MEMORANDUM

To: The Design Advisory Board
From: Mary O'Neil, AICP, Principal Planner
RE: 298 College Street, ZP18-0834 CA/MA
Date: April 10, 2018

File: ZP18-0834CA/MA
Location: 298 College Street (former Ethan Allen Club)
Zone: RH **Ward:** 8E
Parking District: Neighborhood
Date application accepted: March 28, 2018
Additional material submitted: April 2, 2018
Parking District: Neighborhood
Estimated Construction Cost: 15,000,000
Applicant/ Owner: Freeman French Freeman, Inc. / Kyle Dodson for Greater Burlington YMCA
Technical Review: February 11, 2016, December 14, 2017
Request: Redevelopment of the former Ethan Allen Club for the Greater Burlington YMCA; Two stories, approximately 50,000 sf (26,000 sf footprint.) Request for parking waiver.

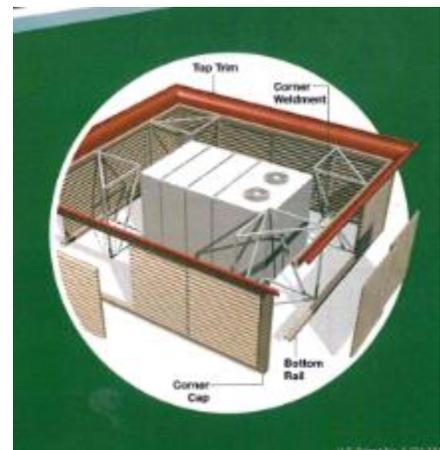
Rooftop equipment will be screened. See attached supplemental information.

The roof plan identifies the location of proposed rooftop mechanicals; all which will be screened via the method identified above.

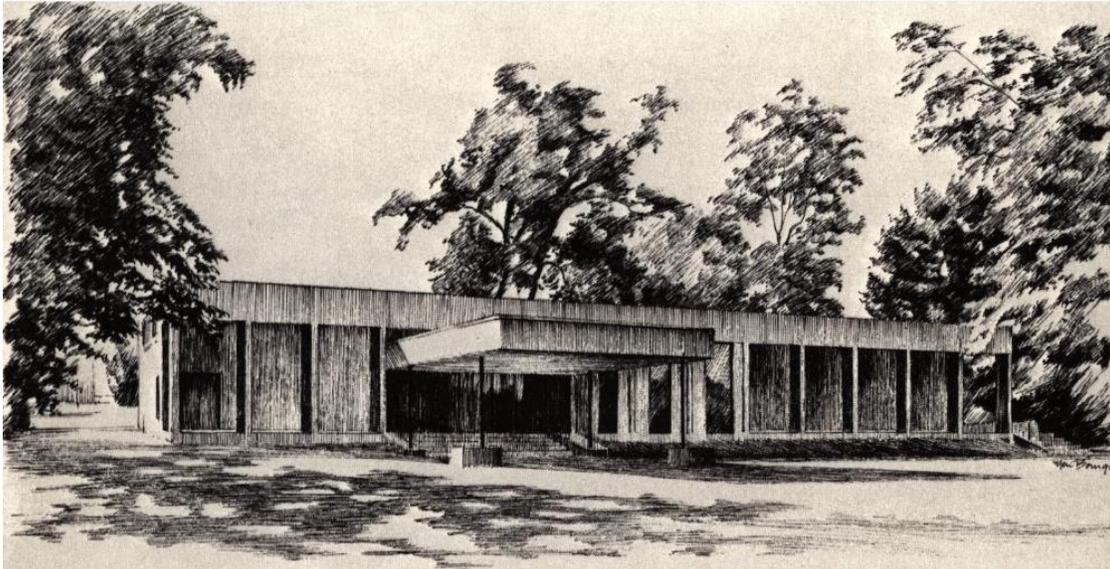
Built in 1972 by noted Burlington architect Julian Goodrich (1922-2010), this building was listed as non-contributing to the **Main Street –College Street Historic District** as ineligible due to age; however, Brian Knight's 2010 *Survey of Modern Architecture* included it as an example of International Style.

As a result of that research, staff consulted with the Vermont Division for Historic Preservation with an inquiry as to eligibility for historic designation. Here is the response from state Architectural Historian Devin Colman:

The building is still only 45 years old, so making a case for eligibility would be a challenge. I consider it to be an example of Formalist architecture as opposed to International Style, with its smooth wall surfaces, projecting roofline and strict symmetry. The brick columns supporting the

projecting roofline on the north and south elevations create an ordered and rhythmic façade, similar to a Classical colonnade. It's an interesting design solution for a building that doesn't really have a front or a back and has to address both College Street and the parking lot, where the primary access is located. Attached is a rendering of the entry, as originally designed.

There aren't a lot of examples of Formalist design in the city; offhand I can think of one other, Votey Hall at UVM (Barr, Linde, Hubbard / 1963).

The above opinion, including the building's age (less than 50 years) and challenge to establish eligibility, results in a determination that the standards of this Section do not apply.
